To: Karl Schwing
District Director, San Diego Coast
California Coastal Commission

Re: W18a - Application A-6-ENC-20-0022, Marco and Nicole Hanlon, 100 & 104 Fifth Street, Encinitas

Table 1.8-1 Study Area Reaches

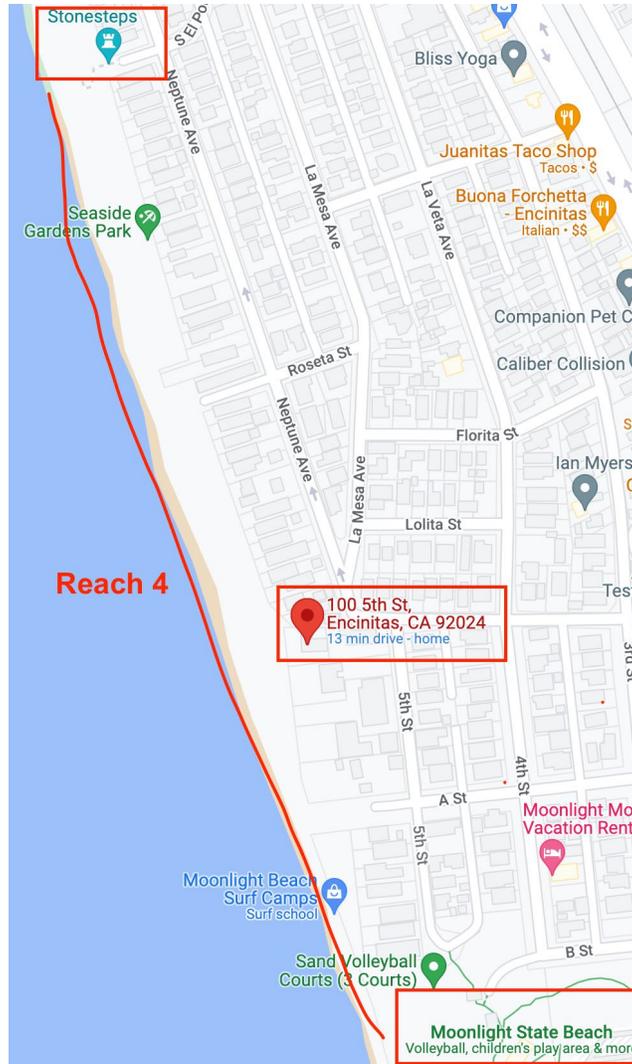
‘Reach 4’ stretches from Stone Steps to Moonlight Beach and includes the relevant coastal stretch of property.

Reach 4 is described as vulnerable to future bluff failure:

“Along the entire reach, except for the southern portion of the reach immediately adjacent to Moonlight Beach, an approximate 2 to 4- foot notch exists at the base of the bluff where notch protection measures have not been instituted. The prevalent notch development coupled with the already over-steepened upper bluff zone is prone to future bluff failures, some of which could be catastrophic.” (page 9, Encinitas & Solana Beach Shoreline Study)

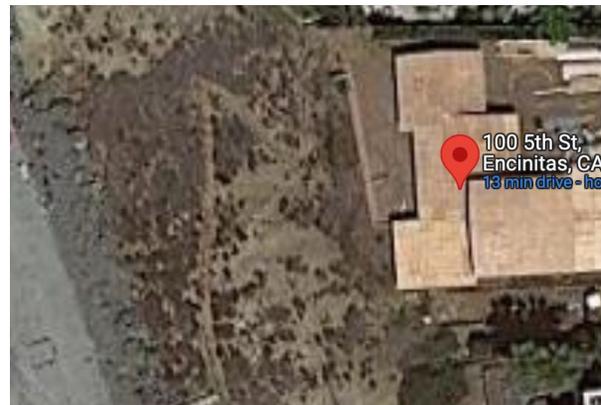
The Commission’s geologist also neglected to use the recent, highly credible, and site-specific retreat rate of 1 ft per year as determined by the ACOE:

“Dr. Street has independently evaluated future bluff retreat at the site using both the SCAPE equation and projections provided by the USGS CoSMoS cliff retreat model. Dr. Street’s analysis used observed historical retreat rates for unarmored bluffs in the project area but avoided the several non-conservative assumptions contained in the TerraCosta analysis. Based on this analysis, under scenarios assuming 6.6 – 7.1 feet of sea level rise by 2100, the coastal bluff at the site could retreat approximately 30 - 32 feet over the next 75 years. Given

the large uncertainties in projecting both future sea level rise and the erosion response of coastal bluffs, this projection is not significantly different than TerraCosta's, assuming an average future bluff retreat rate of 0.4 ft./yr. (page 24, staff report)

The GSL should be calculated using the ACOE's retreat rate and all proposed development should be located landward of that GSL.

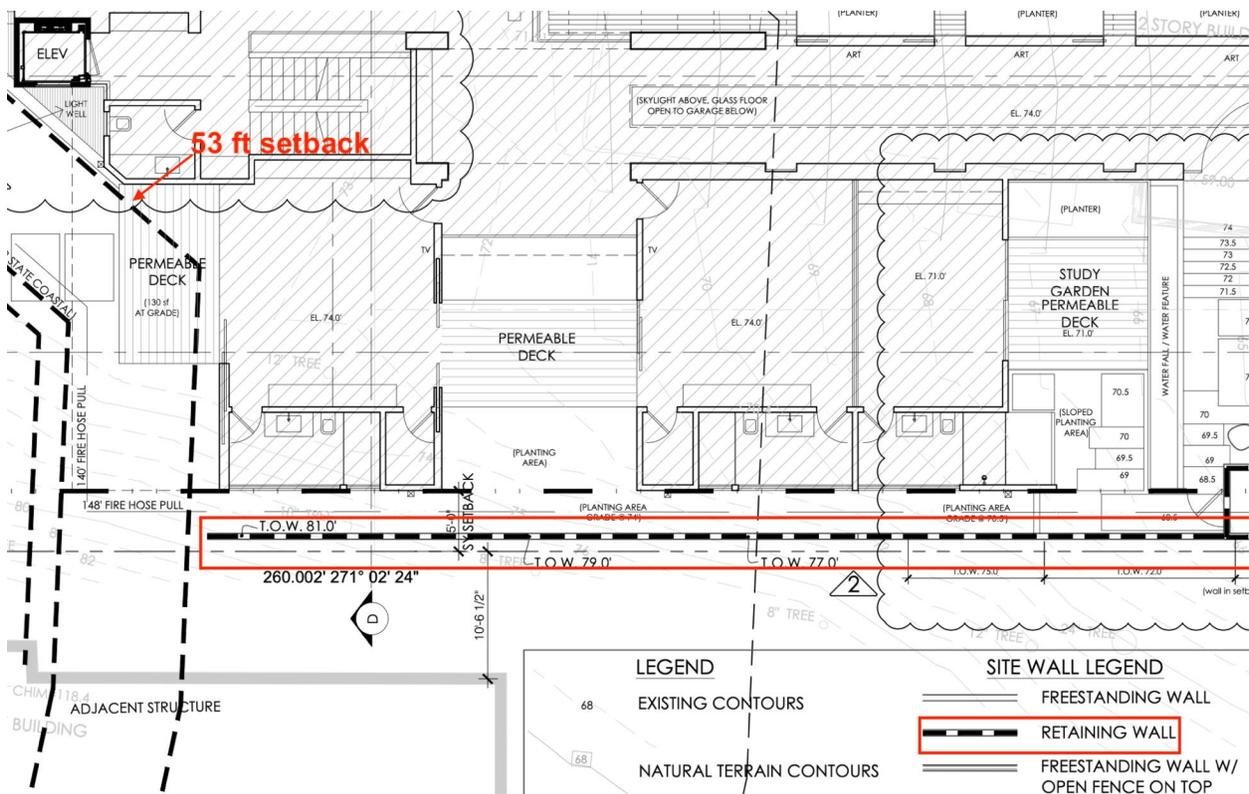
Images from the Coastal Records project³ and Google Maps show the riprap is located directly in front of 100 5th St. While the staff report indicates this riprap is on an adjacent lot, it likely was placed by previous property owners thus is the responsibility of the project applicant. If necessary, a determination of the party that placed the riprap should be made by the enforcement division and the burden to remove it placed on that party. Surfrider Foundation San Diego Chapter will be reaching out within the community as well to try and locate the responsible party. Regardless of

who placed it there, the repair of the riprap other than to remove it as it erodes or moves, should be waived in the present permit.

We believe Special Condition 1(i) should be further strengthened to require removal of the unpermitted riprap. Currently it states:
